From: Kulis, Jerzy, NMENV
Sent: Wednesday, April 06, 2011 4:54 PM
To: 'Everett, Mark C'; Cobrain, Dave, NMENV; Dale, Michael, NMENV
Cc: Ball, Theodore T; Shen, Hai; Woodworth, Lance A; Lynnes, Kathryn D
Subject: RE: R-61 proposed well design

R-61 Well Objectives

R-61 Recommended Well Design

Figure 2. Proposed well design, R-61 (Qbt 3, 2, 1v, 1g = subunits of the Tshirege Member of the Bandelier Tuff; Qbo = Otowi Member of Bandelier Tuff; Qbog = Guaje Pumice Bed, Tpf = Puye Formation; Tjfb = Miocene pumiceous unit beneath the Puye Formation).

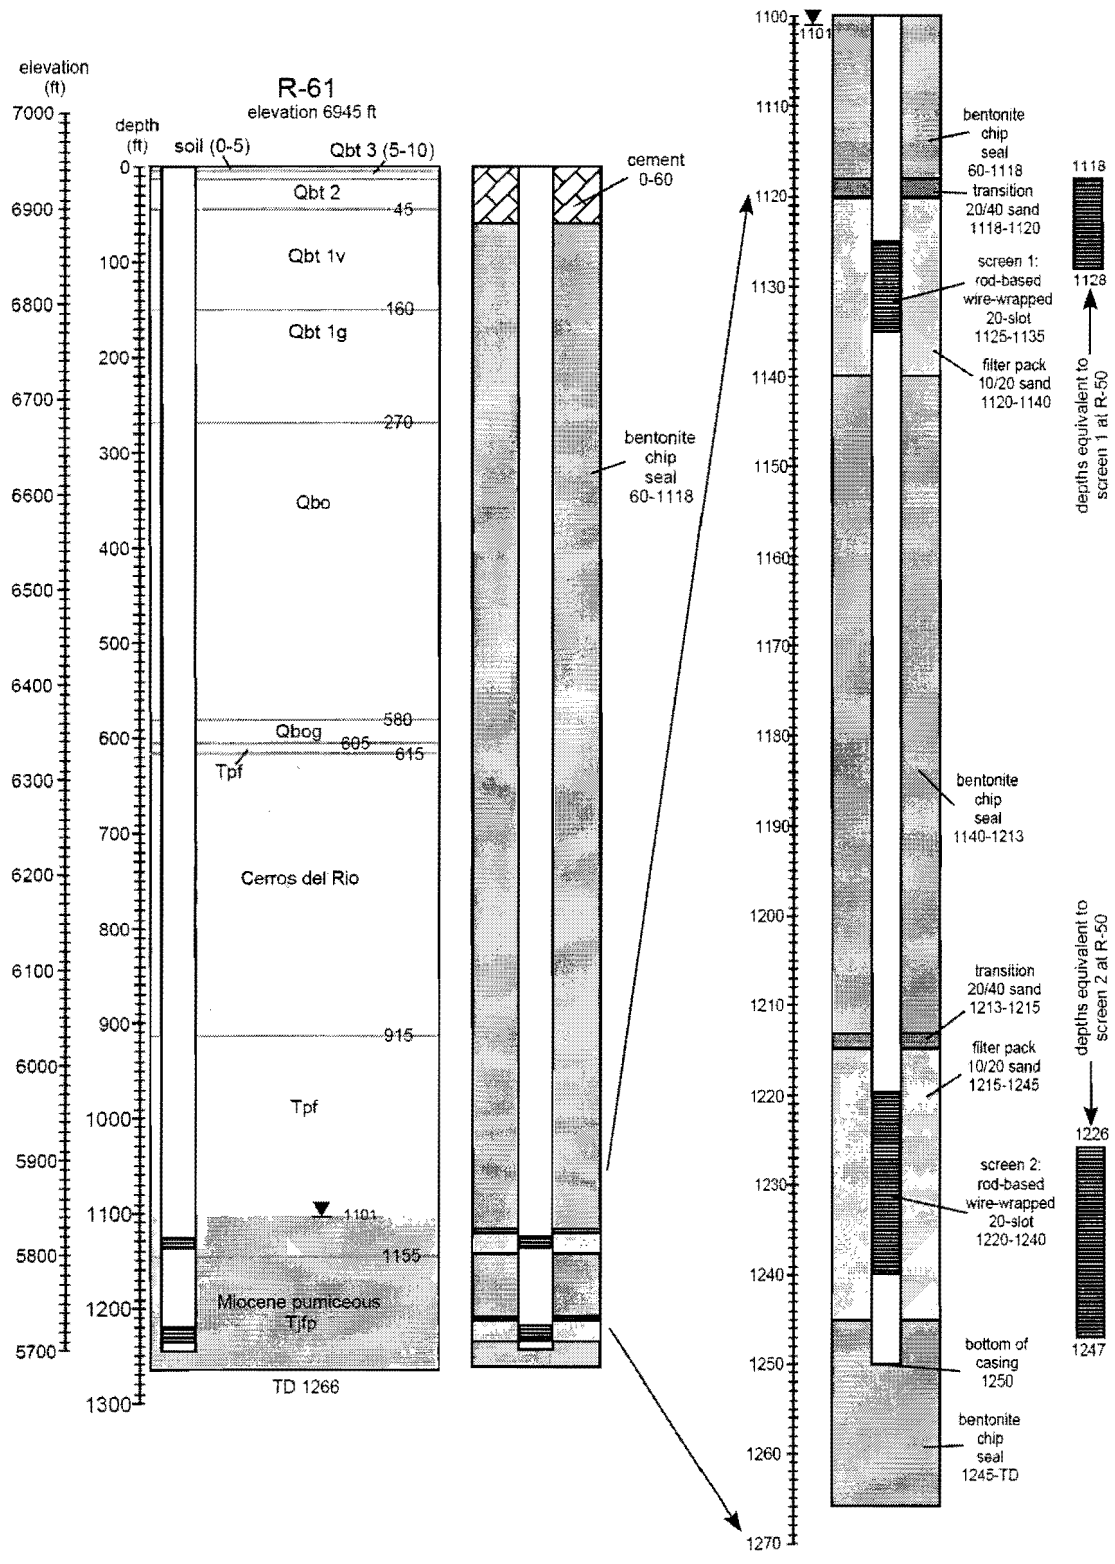
This e-mail serves as NMED approval for installation of regional aquifer well R-61 as proposed in the document attached to the original e-mail received by NMED on April 6, 2011 at 2:48 PM. This approval is based on the information available to NMED at the time of the approval. NMED understands that LANL will provide the results of preliminary water-quality sampling, any modifications to the proposed well design, and any additional information related to the installation of well R-61 as soon as such information becomes available. **LANL must notify NMED of well development and aquifer testing at R-61 at least three business days prior to commencing these activities.** LANL shall give notice of this installation to the New Mexico Office of the State Engineer as soon as possible.
